ACCESS REPORT

ISSUED FOR DEVELOPMENT APPLICATION

12 The Strand, Dee Why, NSW 2099

Access report BCA 2022
22/05/2025

Figure | Mark-up of the entrance doors required to be accessible | Source: Studio Johnston architects

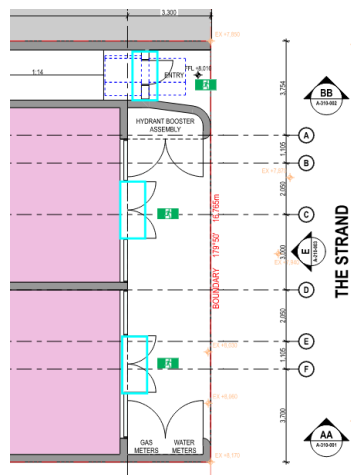
For the purposes of Clause D4D3(2) of the BCA, the following pedestrian doors are required to be accessible:

- Main entry door on the eastern façade which adjoins 'The Strand'; and
- Entry doors to the retail premise on the eastern side of the building which adjoins 'The Strand'.

Note: Not less than 50% of pedestrian doors are required to be accessible; and as the building contains a floor area of more than 500 m² any entrance which is not accessible cannot be located more than 50m from an accessible entrance.

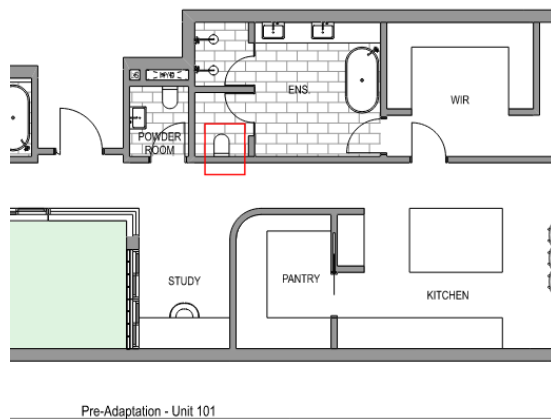
Item	Performance Solution	DtS Provision
1.	<p>Circulation Space for Ambulant Sanitary Compartments (AS 1428.1-2009, Section 16)</p> <p>The male and female sanitary compartments do not comply with the required circulation space for ambulant sanitary facilities in accordance with Section 16 of AS 1428.1-2009.</p> <p>We recommend that a Performance Solution is to be done to justify the alternative layout or reduced circulation space in the ambulant sanitary compartments, demonstrating that they offer a comparable level of accessibility in accordance with the intent of AS 1428.1-2009 and the Premises Standards.</p> 	F4D5

Pre-adaptation Plan Unit 101

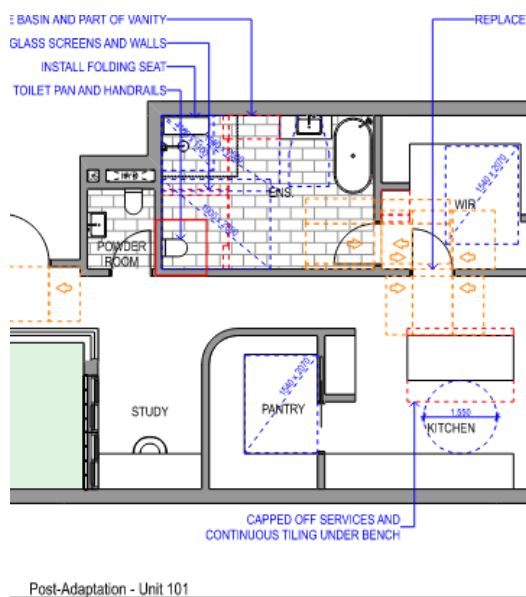
Item	Design Consideration	DtS Provision
2.	The toilet in the ensuite of Unit 101's pre-adaptation plan is located differently from that shown in the post-adaptation plan and therefore does not meet the requirements for adaptable housing.	-

To comply, the toilet location must remain consistent between the pre- and post-adaptation layouts. Please update the plans accordingly and must comply with the requirements of AS1428.1-2009.
